APPLICATION NO.	FILING DATE	FIRST NAMED INVENTOR	ATTORNEY DOCKET NO.	CONFIRMATION NO.
10/591,145	08/30/2006	Mitsunori Nakatani	1032404-000160	6140

Office Action Summary	Application No. 10/591,145	Applicant(s) NAKATANI ET AL.	
	Examiner Jayne Mershon	Art Unit 1795

DETAILED ACTION

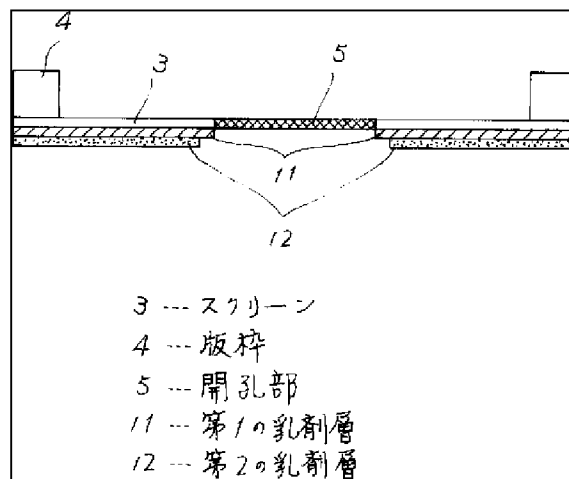
Regarding claim 12, Hikoharu teaches a printing mask (see below figure) comprising:
a first resin or emulsion layer (21) that is applied to the mesh (see paragraphs [0010] and [0014];

a second resin or emulsion layer (22) is formed directly on a surface of the first resin layer, wherein the thickness of the second resin layer is approximately 10 μm (see paragraph [0014]);

a pattern forming portion (i.e. opening 5, plus the area covered by first emulsion 11, but free of second emulsion 12) wherein the pattern forming portion is located in a region corresponding to a pattern to be formed on a printing object; wherein the pattern forming area is free of resin from the second resin layer. It is the examiner's position that the claim limitation stating "a pattern forming area in which the second resin layer is not formed" means a pattern forming area void of the resin or emulsion that makes up the second resin layer.

Further, Hikoharu teaches a mask portion in which the first resin layer and the second layer are formed, i.e. portion where both first emulsion (11) and second emulsion (12) are present (see paragraphs [0001] and [0010]-[0011]).

a peripheral portion of the printing area, but included in the printing area as defined previously within this claim, in which the first resin layer (11) is formed, but the second resin layer (12) is not formed, wherein the peripheral portion is located within the pattern forming portion and along a periphery of the pattern forming portion (see paragraphs [0001], [0007], and [0010]-[0011]).

Hikoharu does not specifically teach a mask wherein the first emulsion layer is formed inside the mesh, nor does Hikoharu teach that the second emulsion layer is 3 μm or less.

Hikoharu does teach the first emulsion layer is a gelatin photosensitive emulsion (see paragraph [0014]). It is the examiner's position that the emulsion being within the mesh is inherent to gelatin photosensitive emulsion as evidenced by Takeuchi et al.

Takeuchi et al. does teach wherein an emulsion formed on a mesh, includes resin formed inside the mesh (see figs. 6A and 6B, paragraphs [0060]-[0061]). Takeuchi et al. states the resin is formed on the mesh, yet it is demonstrated in the figs. 6A and 6B that the emulsion is inside the mesh as well as on the mesh.

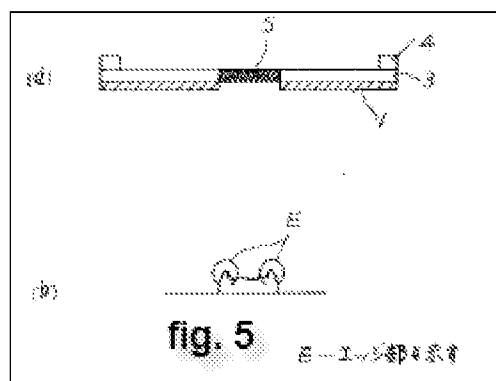
Regarding claim 13, Hikoharu teaches a printing mask wherein the peripheral portion (11) is located within a range corresponding to a width of a bulge from an end of the electrode pattern, which is formed at the end of the electrode pattern on forming the electrode pattern (see paragraphs [0006] and [0008]). Specifically, the edge portion is thicker as described (see fig. 5 below) and the problem is solved by the two layer emulsion. Note: see claim 12 regarding language “electrode pattern”.
